**TOWN OF BAY HARBOR ISLANDS
MORRIS N. BROAD COMMUNITY CENTER
1175 95TH STREET
BAY HARBOR ISLANDS, FL 33154**

DEVELOPMENT & REVIEW COMMITTEE MEETING

AGENDA ITEM REPORT

ITEM: Review and discussion of the Site Plan Application by 9291 EBH LTD, to construct a new 32-unit multi-family development to be located at 9291-9301 East Bay Harbor Drive. Enclosed are the Site Plans and the Staff Report prepared by Town Planner, Lorrainia Belle.

SITE PLAN		Sheet No.
Date	11-26-2025	A2.00
Scale		
Project	2567

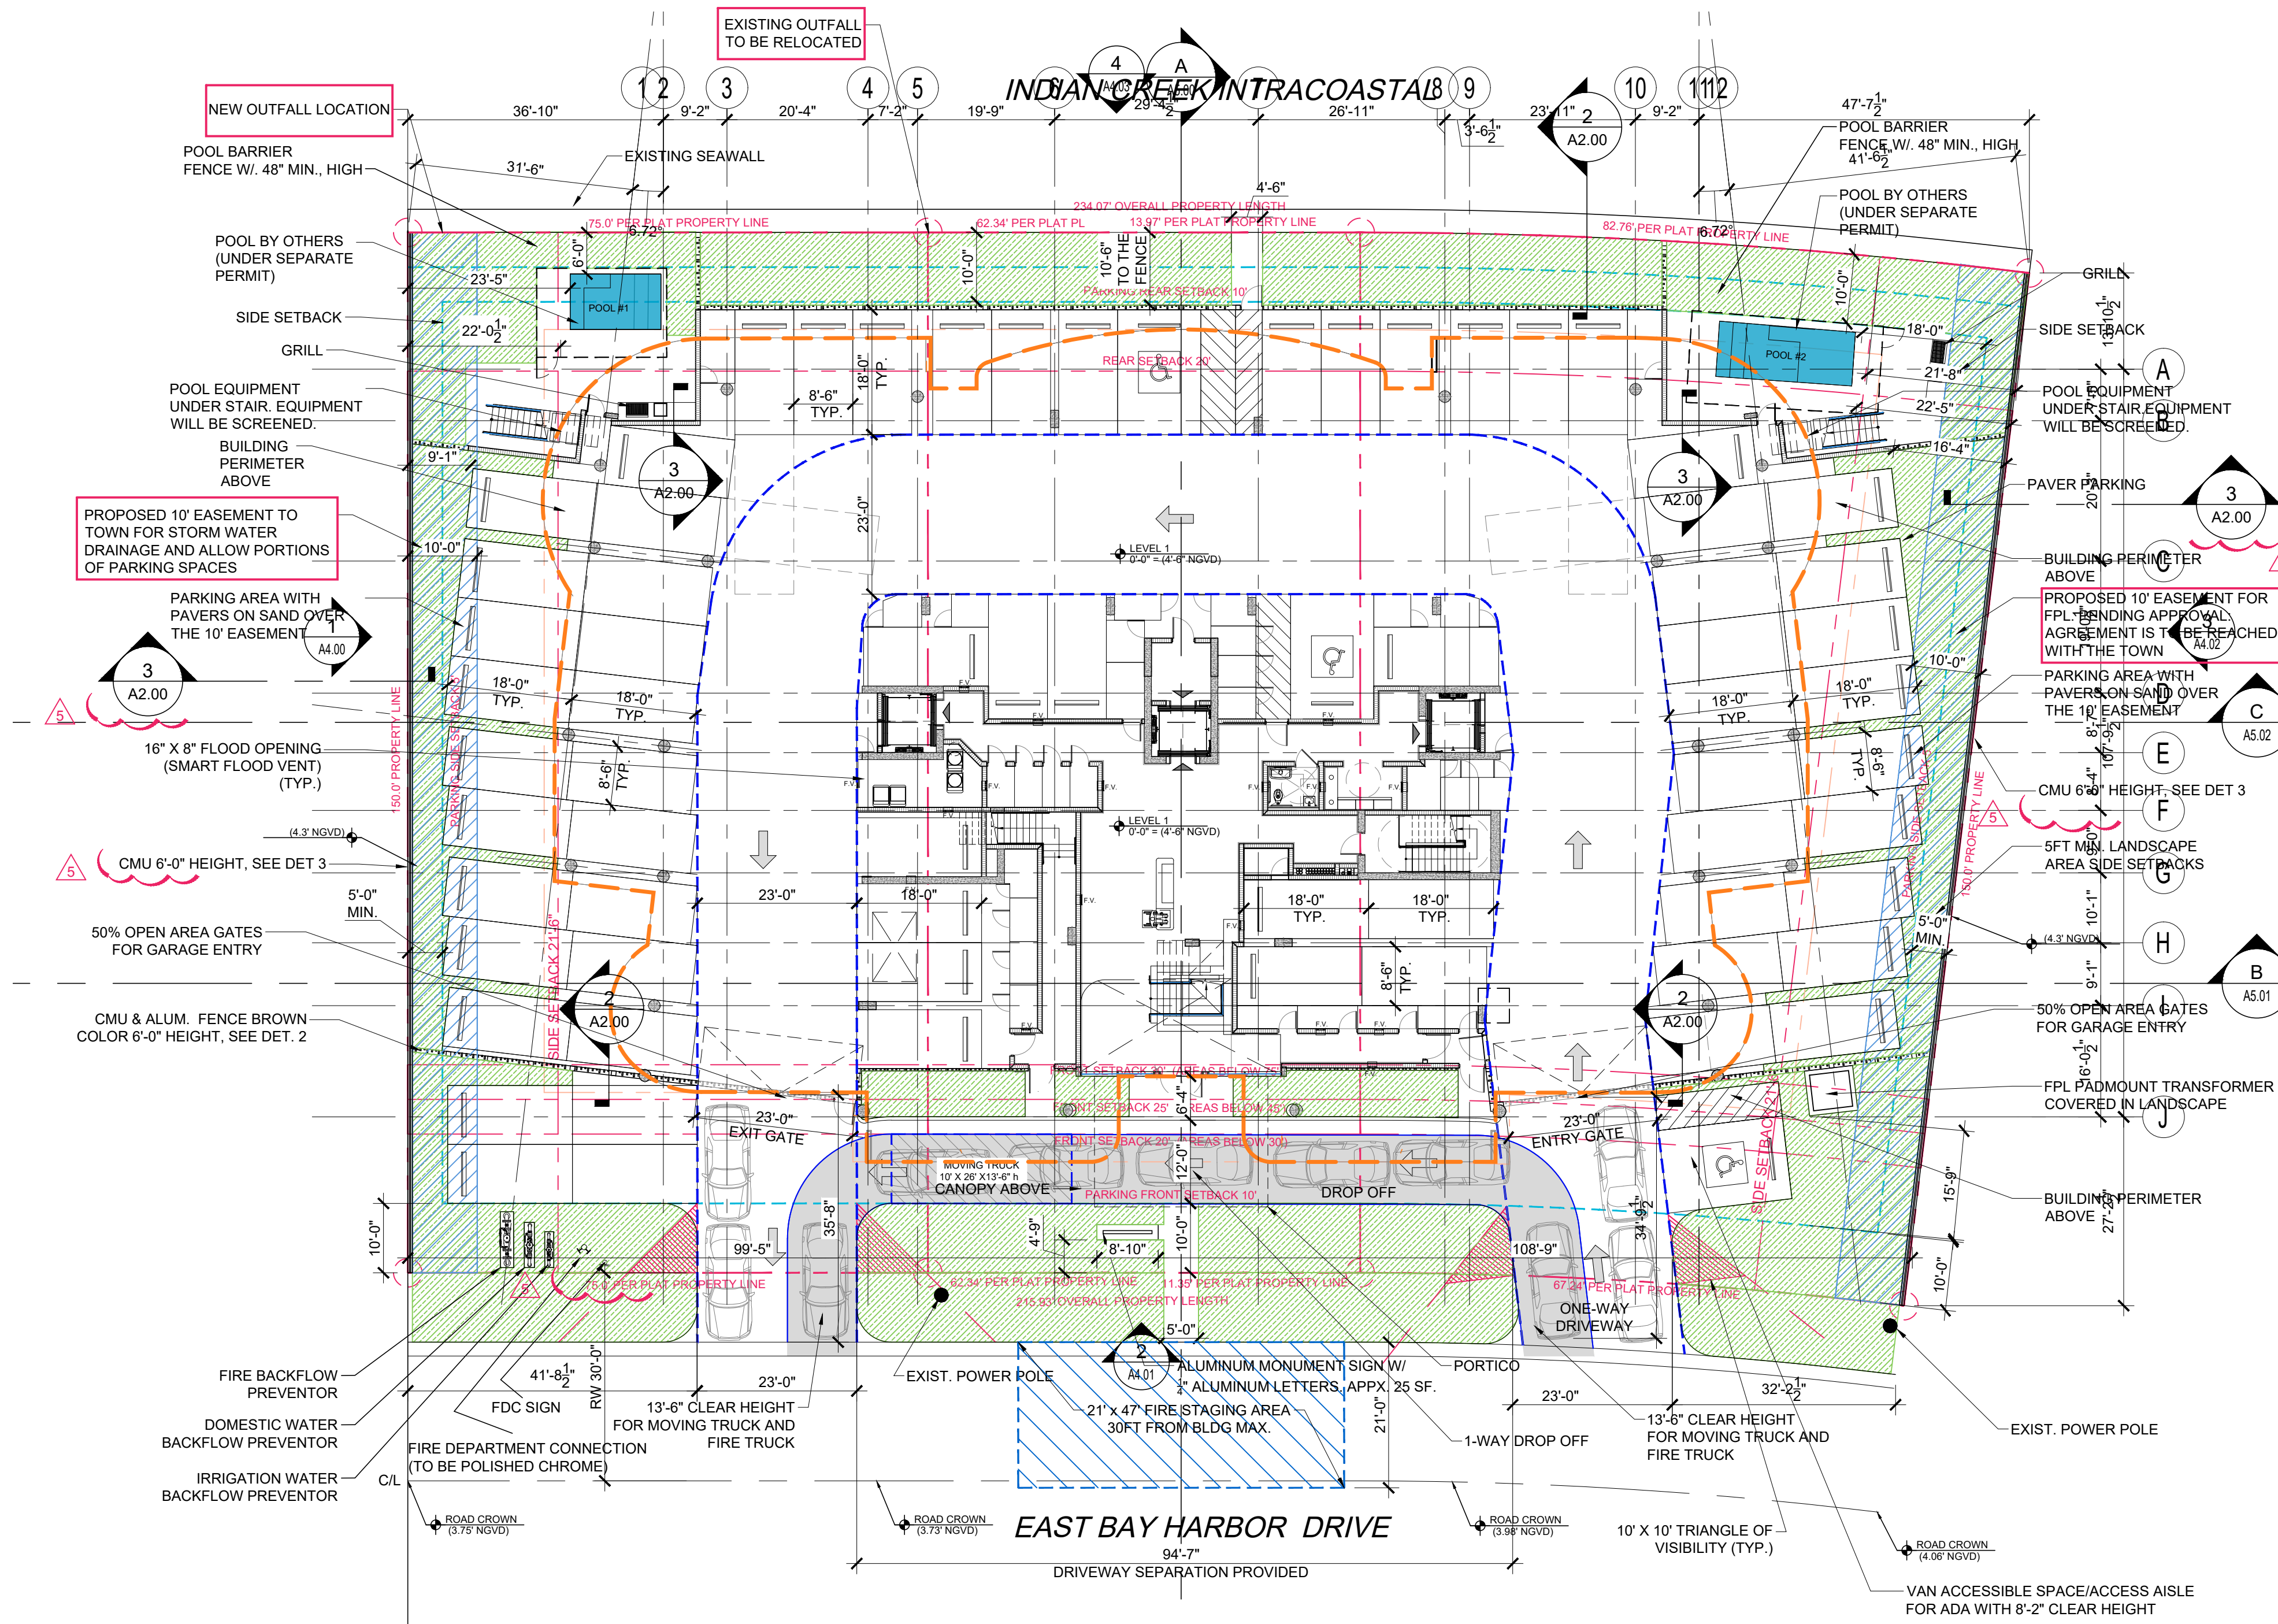
3. Pg A2.00:
 - a. Please provide the setback for the wall and the fence.
 - b. Please note on plans the following: Permit required for walls or fences. Sec23-12(22)(h)(5) If any wall or fence is to be constructed on a common property line, written permission from any adjoining lot owner shall be required to be submitted to the town with the permit application to construct, finish and/or maintain the exterior of the wall facing the adjoining owners lot. Any damage done to an adjoining owners property shall be repaired and/or replaced by the applicant.

Comment 4a: Pg A2.00: The FDC sign needs to be within the property line.

Comment 4b: Pg A2.00: Fence 3 DET, is located where on the plans?

Comment 5: Pg A2.00 the side property line labels the CMU wall and Alim fence, but on pg. A4.00 is illustrating a CMU wall, please fix it.

Reply: *The FDC sign has been placed within the property line. Please see page A2.00*

Reply: *All instances of Fence 3 have been labeled on the site plan. Please see page A2.00*

Reply: *The fences on the side property lines have been properly labeled as CMU walls. Please see page A2.00*

Date	11-26-2025	Sheet No.	A4.07
Scale			
Project	2567

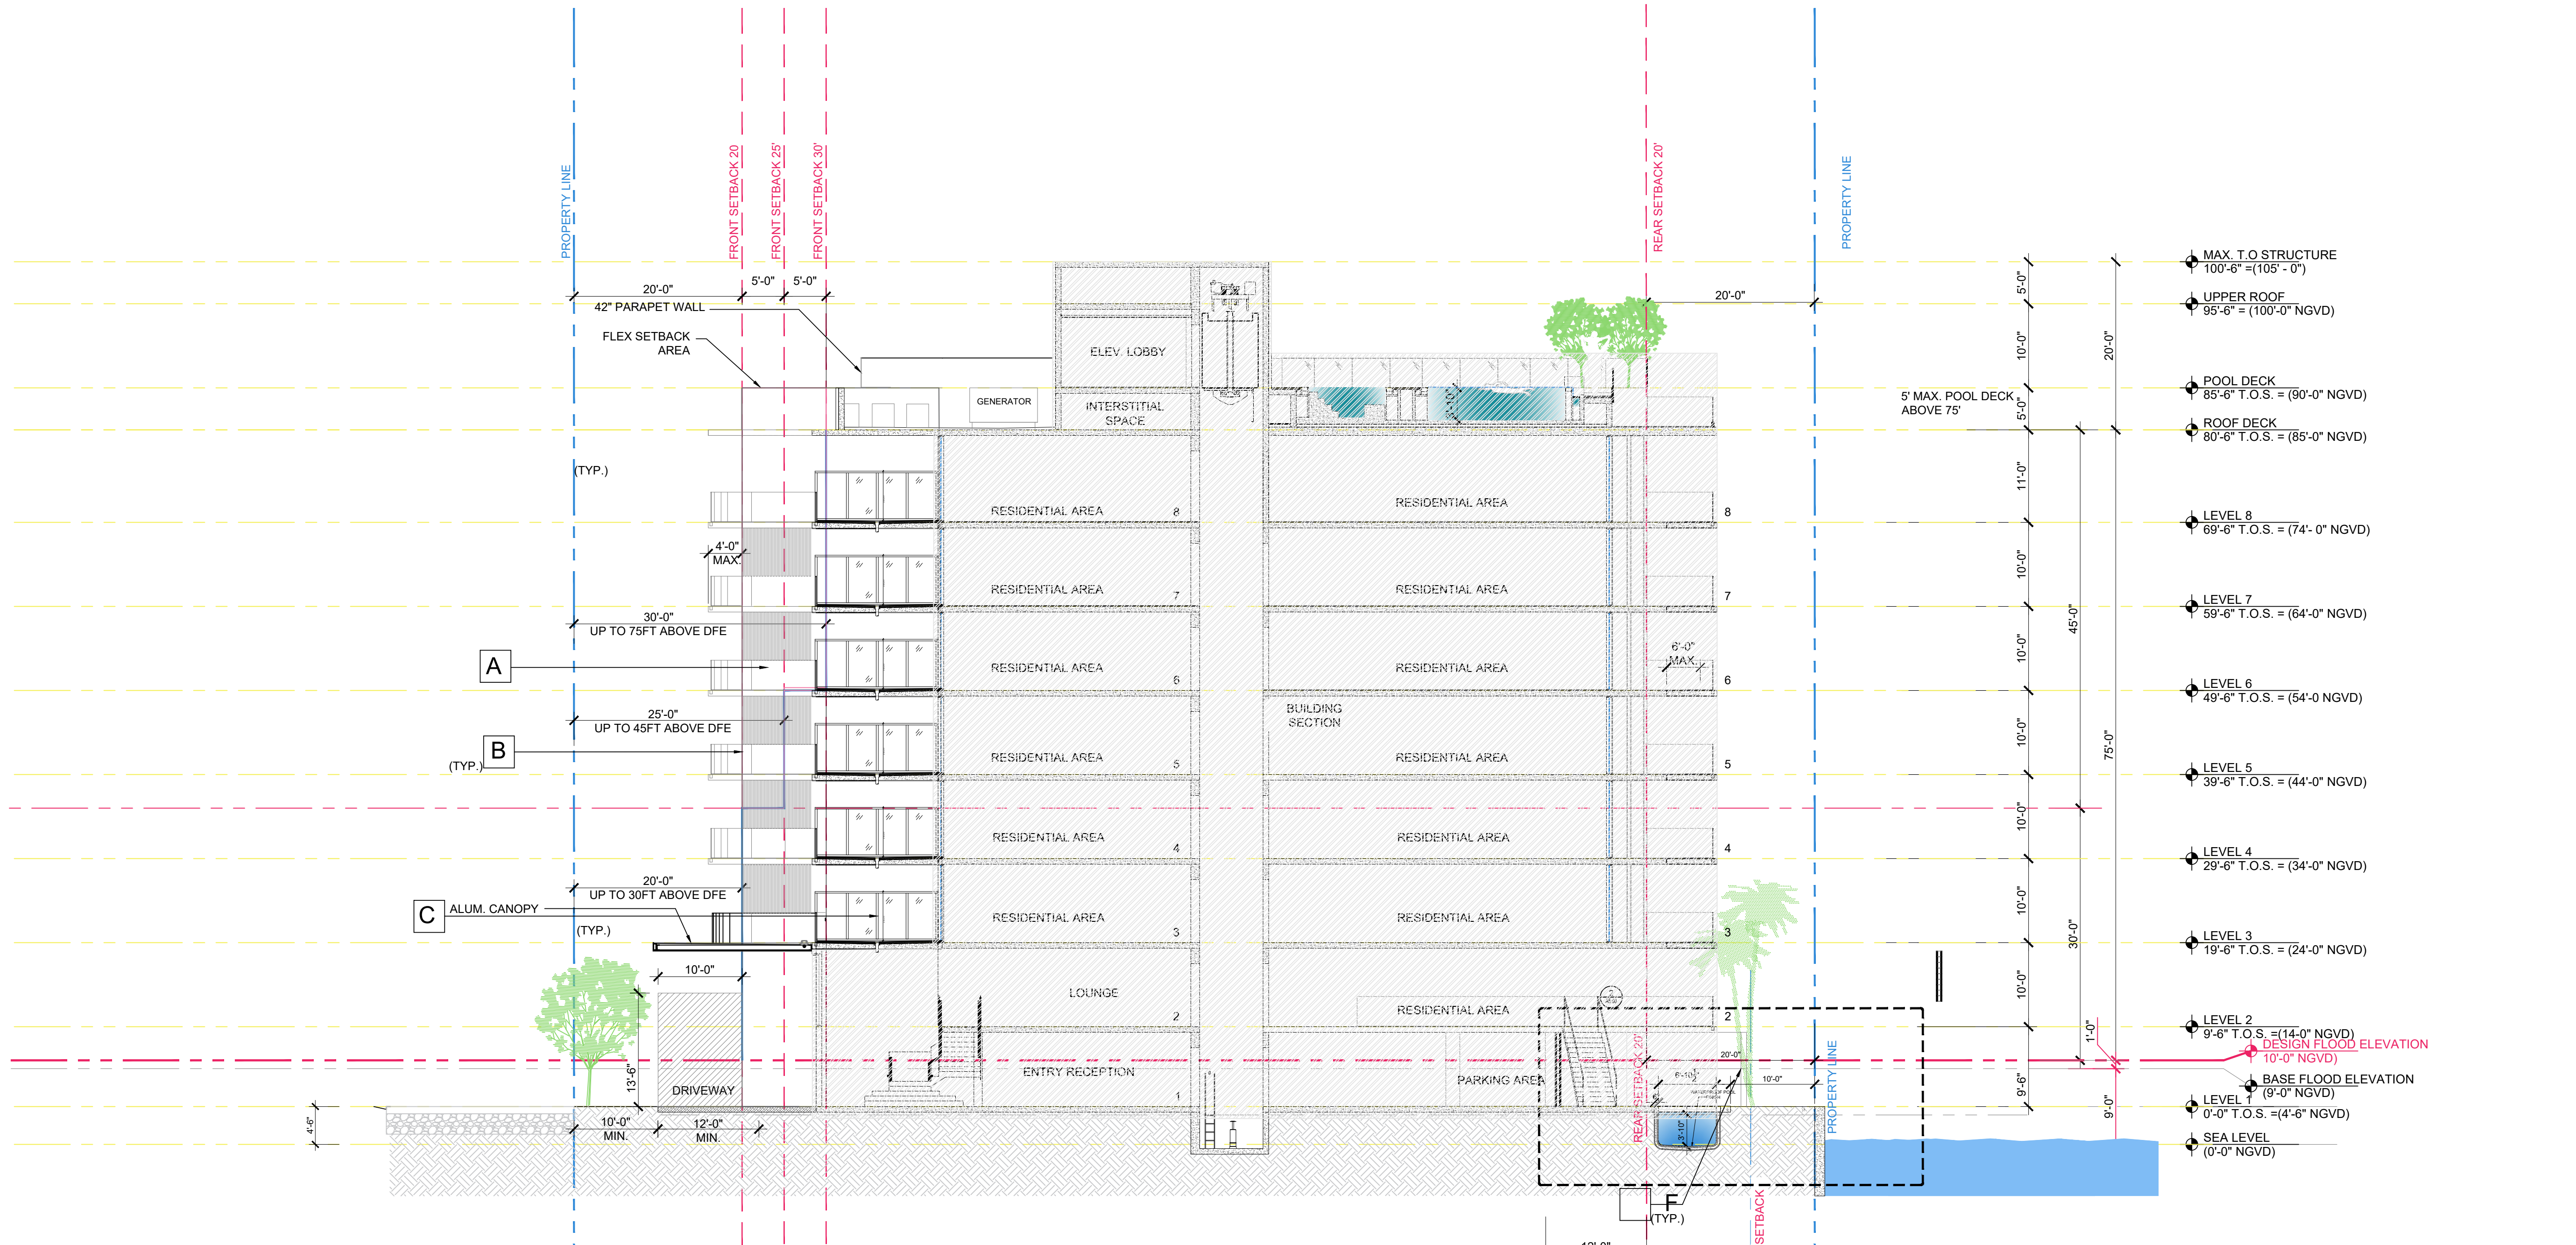
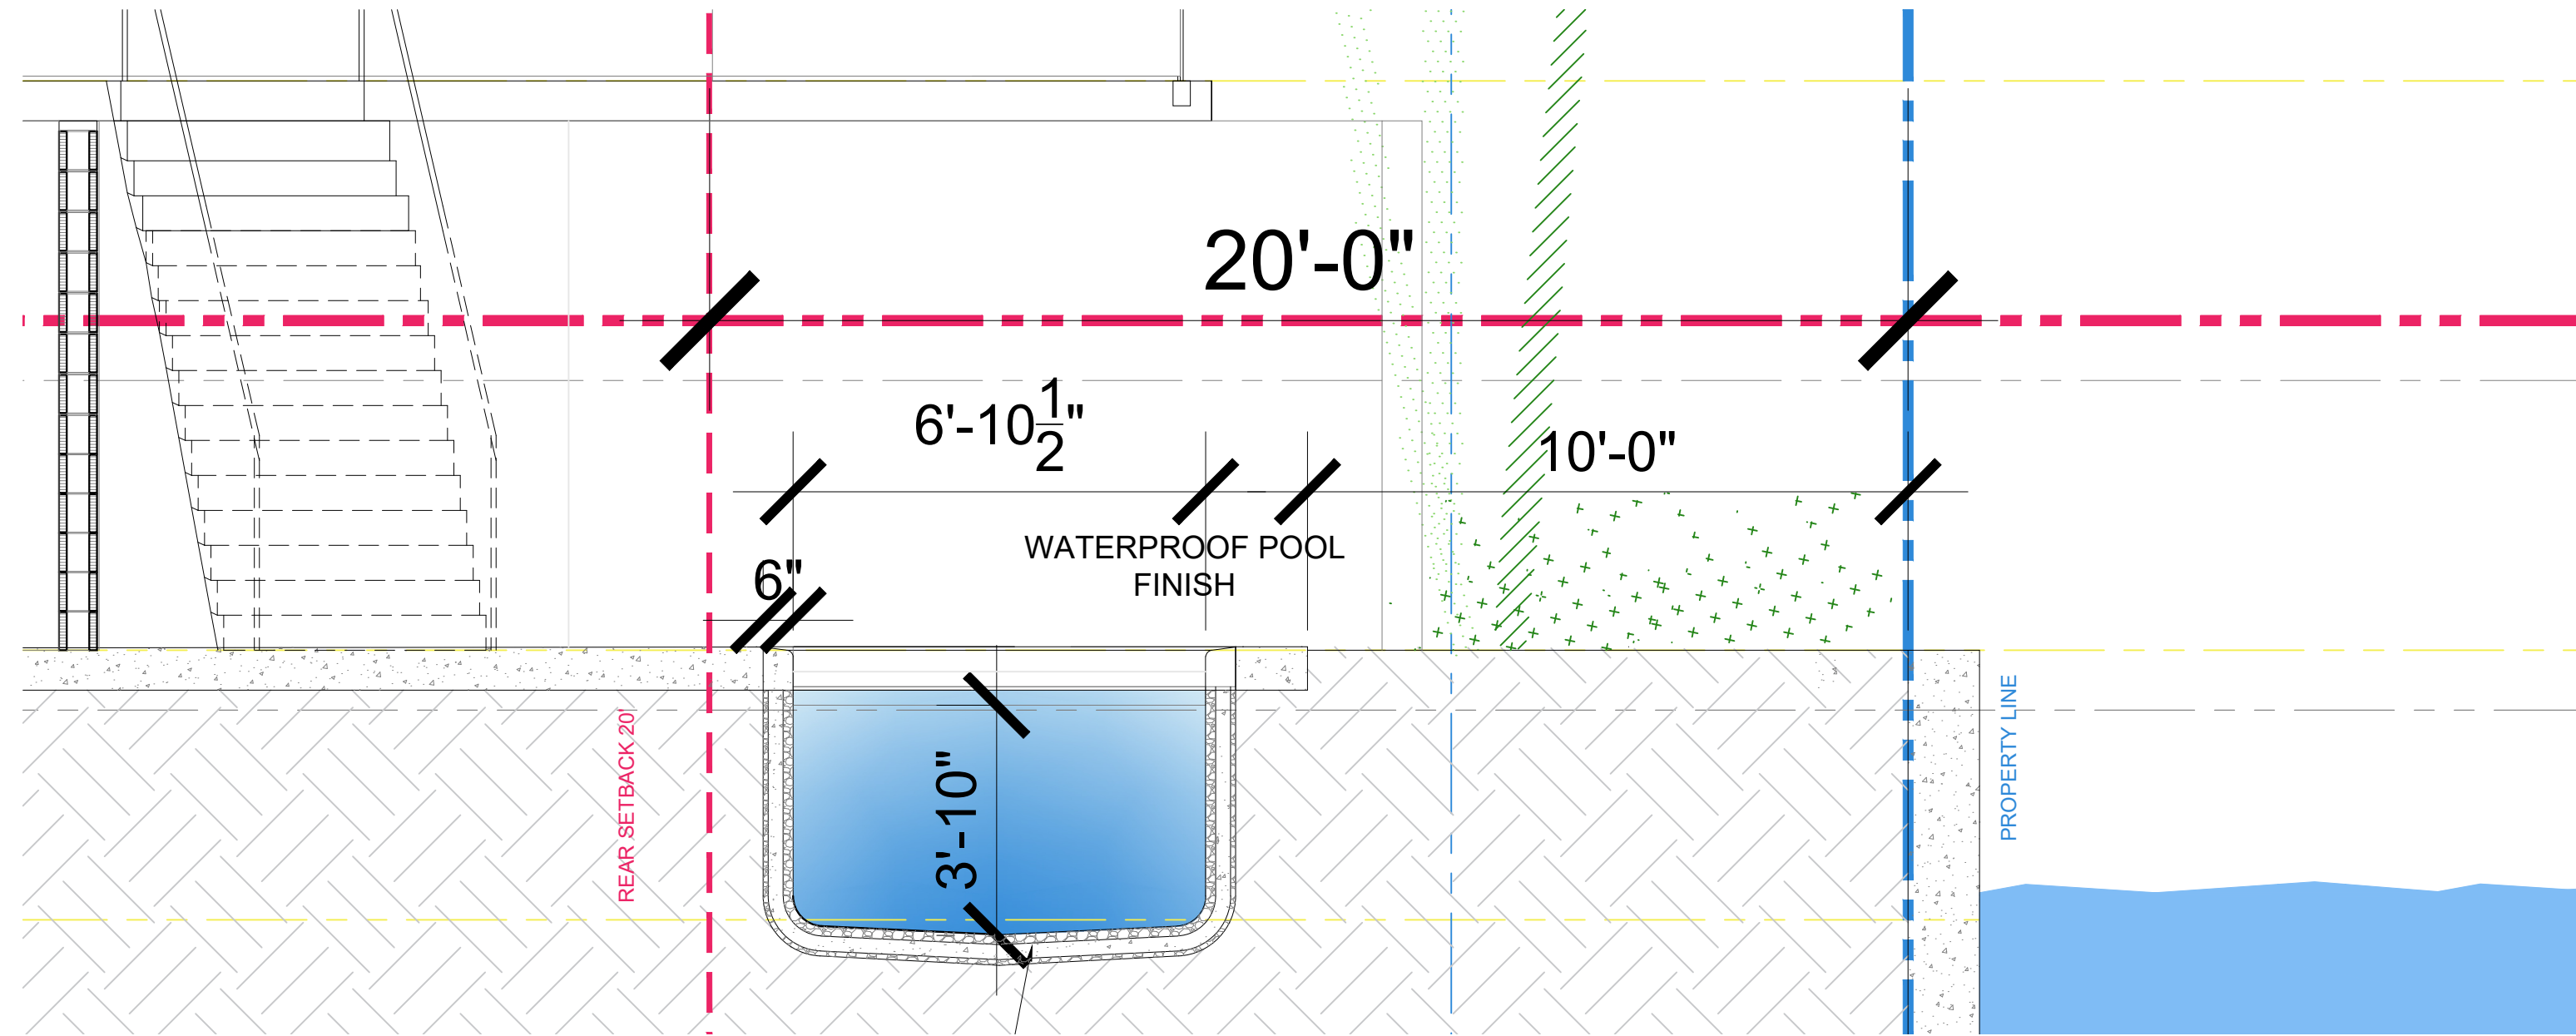
9. Provide the section with detail of the ground level pools.
 - a. Only the South Pool is on page A4.07. Please provide the North detail.
10. Please add a note to the roof deck that the private pool equipment will be screen.

Comment 9a: Pg A4.04 and A4.05: the pool is showing in the setback requirement and does not match the site plan. The is measured from the property line not the location of the seawall. Please fix it.

Reply: *Ground floor pool detail has been revised to match the site plan. Please see page A4.07*
